STAFF'S
REQUEST ANALYSIS
AND
RECOMMENDATION

06SN0144

Henry Jones Family, L.C.

REQUEST: Rezoning from Residential (R-9) and Light Industrial (I-1) to Residential Townhouse (R-TH) with Conditional Use Planned Development to permit exceptions to Ordinance requirements.

065N0144-1

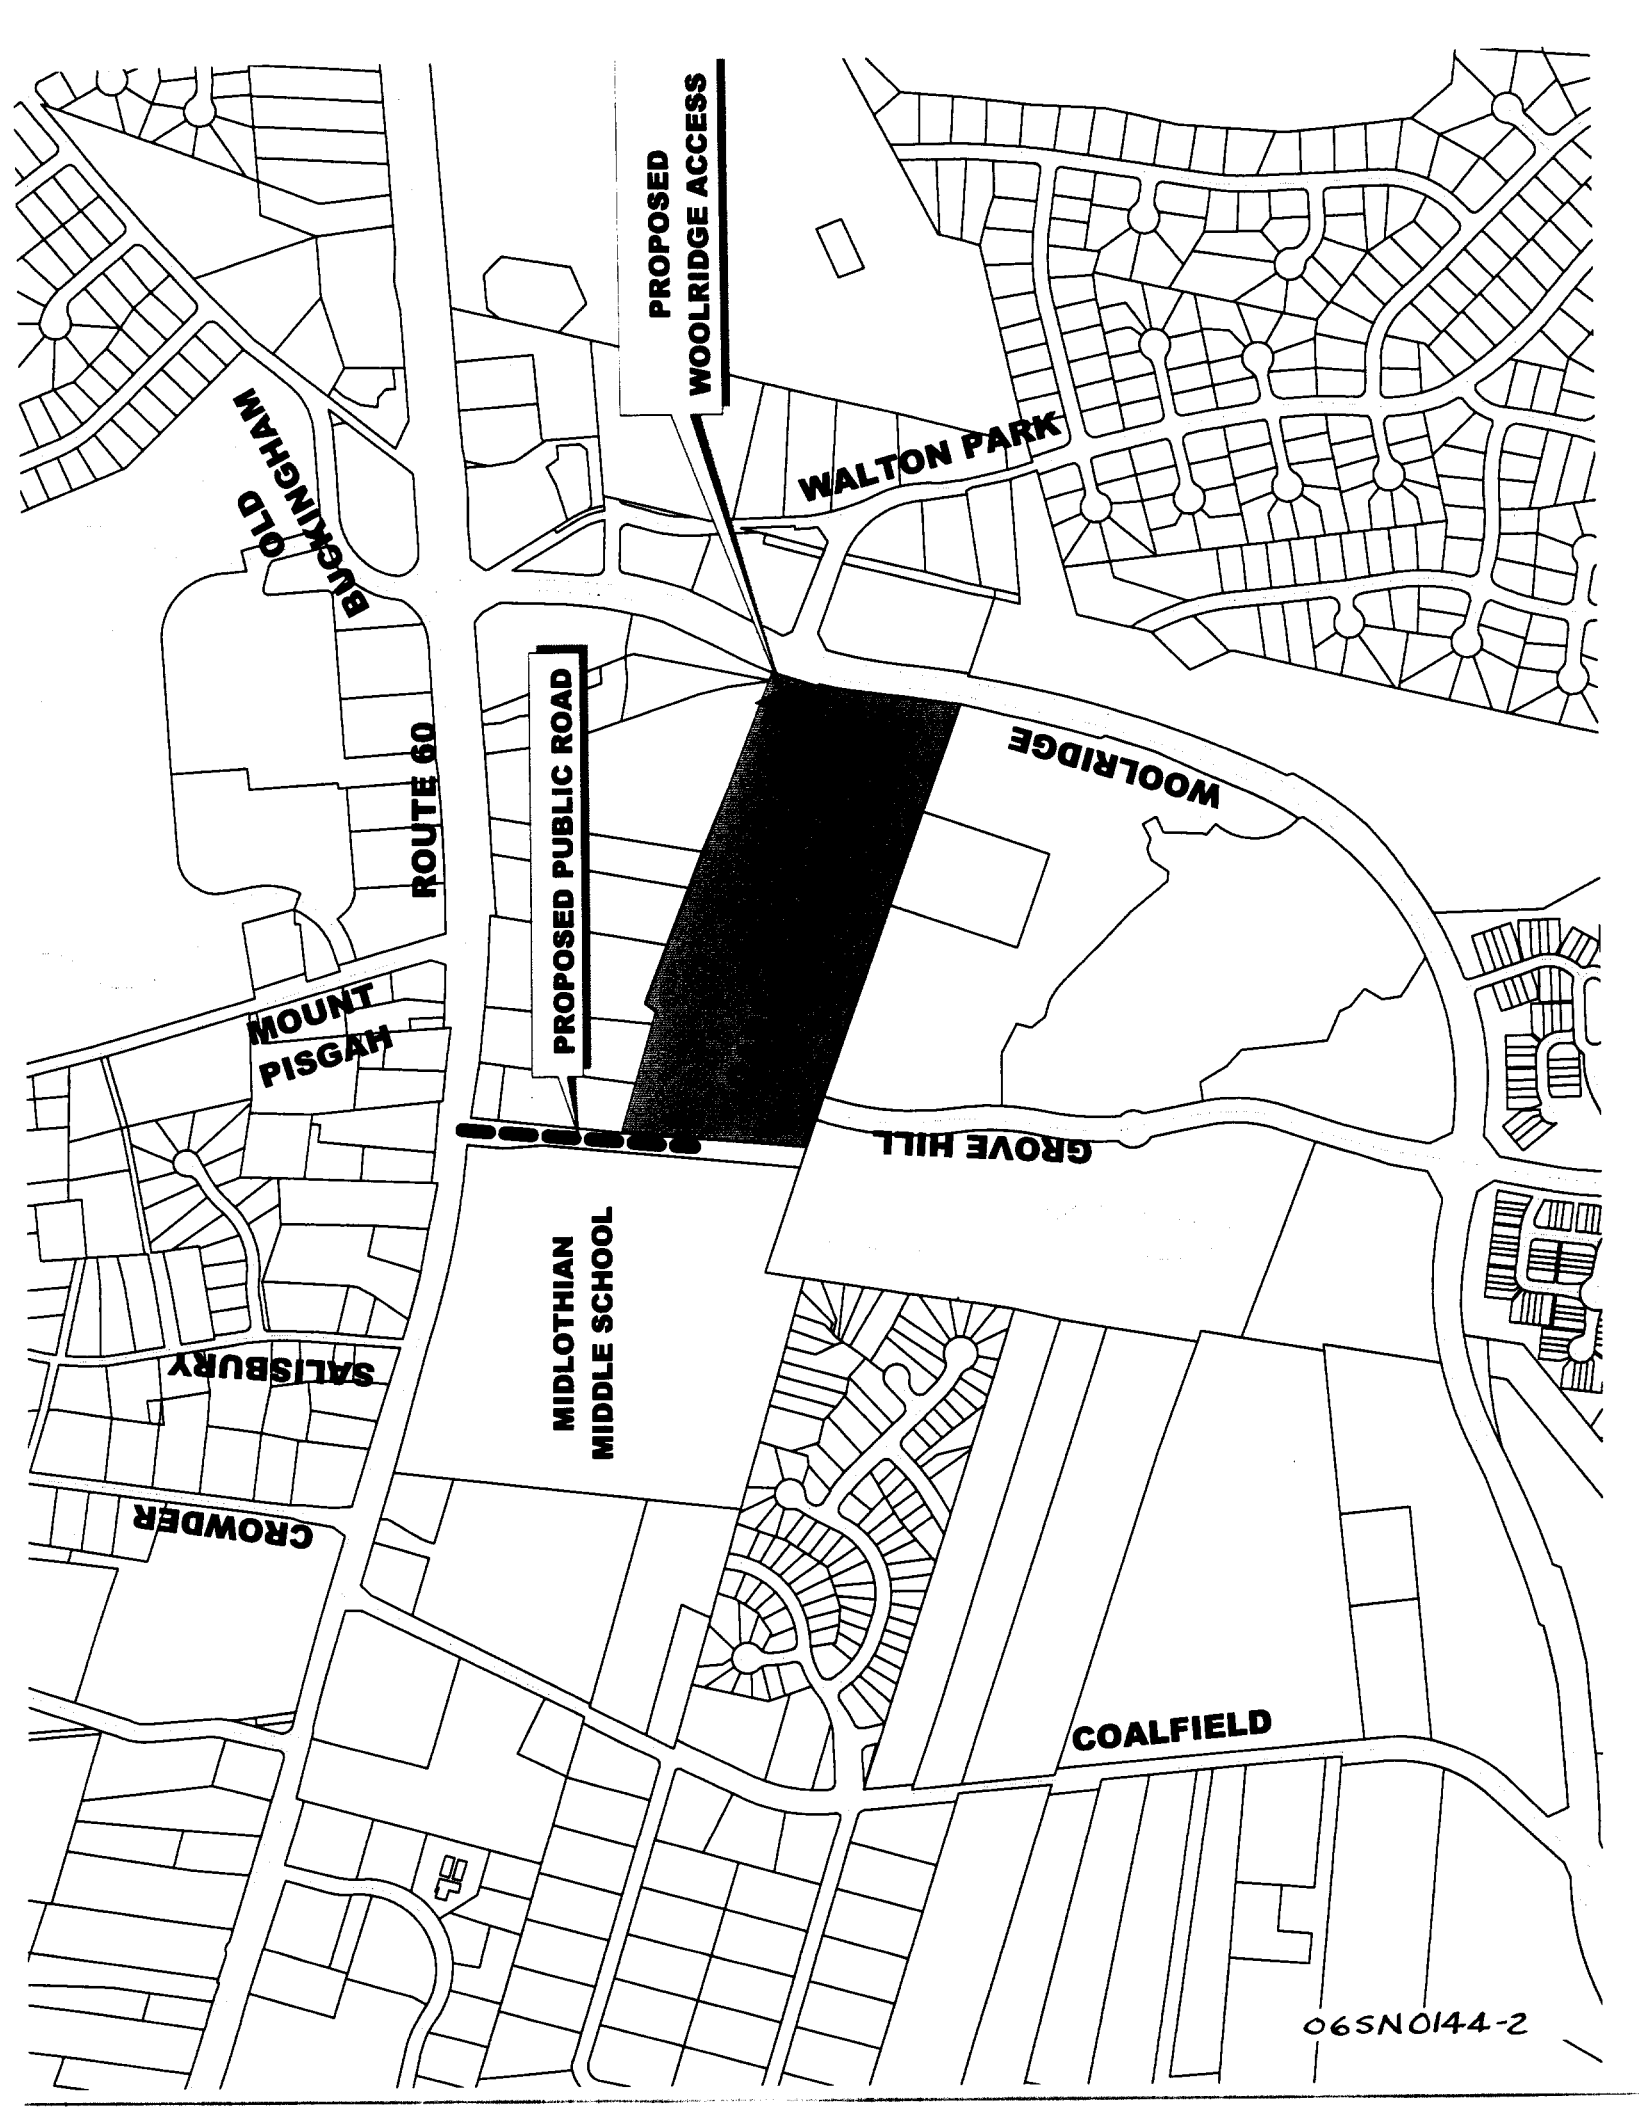
- A. While the Midlothian Area Community Plan suggests that the area is appropriate for a mix of office, commercial and residential uses, this isolated proposal fails to insure the coordinated integration of these residential uses with future commercial development on surrounding properties.
- B. The proposal fails to provide the village core development standards along North Woolridge Road therefore the village character along North Woolridge Road established by properties to the north and south will not be continued along the

roadway at the request property. In addition, while sidewalks and street trees are being provided within the development, there is no guarantee that these features will be consistent with those provided throughout the village.

- C. The requested exception to the provision of off-street parking may result in deficiencies in parking.
- D. The requested exception to the provision for common areas between townhouse groups creates the perception of excessive development density and eliminates pedestrian access between unit groups.

The Ordinance requires the provision of two (2) off-street parking spaces for each dwelling unit. An exception is requested to permit parking within garages to be credited towards this minimum requirement (Textual Statement Section 7). This exception generates two (2) concerns, given that garages are often used for purposes other than parking of residents' vehicles, there may be a lack of on-site parking not only for residents but also for visitors. Further, should garages later be converted to storage or living spaces, off-street parking areas would be eliminated. Therefore, off-street parking should be provided outside of private structures, whether in individual driveways or in common parking areas within the development. Staff recommends that Textual Statement Section 7 not be accepted.
